SAFETY NOTICE - 1A

Non-ACS Should Bolt

MODEL AFFECTED:	DEFIANT NON-ACS SWING ARM SYSTEM
SUBJECT:	VISUAL INSPECTION AND APPLICATION OF THREAD LOCKER PER THE ASSEMBLY INSTRUCTIONS to the provided updated securing bolt for the Non-ACS Swing Arm support pegs.
COMPLIANCE:	PART 1: SAFETY NOTICE 1A - Conducted prior next flight
	PART 2: VISUAL INSPECTION Performed prior and after all flights
	PART 3: Updated part installation

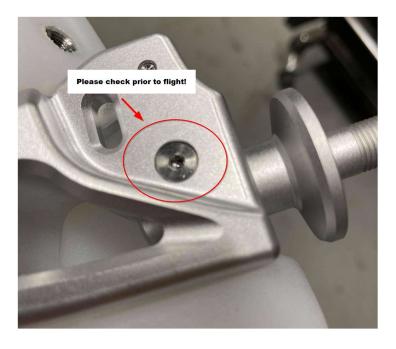
This safety notice is to alert and educate pilots on the importance of thread locker application and to a limitation regarding the shoulder bolt that locks the Non-ACS swing arm support peg to the Defiant paramotor support brace. The design intent with the Non-ACS system was that once the system was installed, it was not to be removed except for approved maintenance. It has been brought to our attention that pilots have been regularly removing/installing the swing arm support system and potentially flying without the application of thread locker to the securing bolt. It is critically important the specified thread locking compound be applied where requested to ensure flight safety.

- 1. Remove existing Shoulder Bolts (4).
- 2. Apply THREAD LOCKER to threads of bolts.
- 3. Thread in bolts and tighten.
- 4. Apply THREAD LOCKER to protruding threads.
- 5. Thread lock nut on and tighten.
- 6. Repeat for all Shoulder Bolts (4).
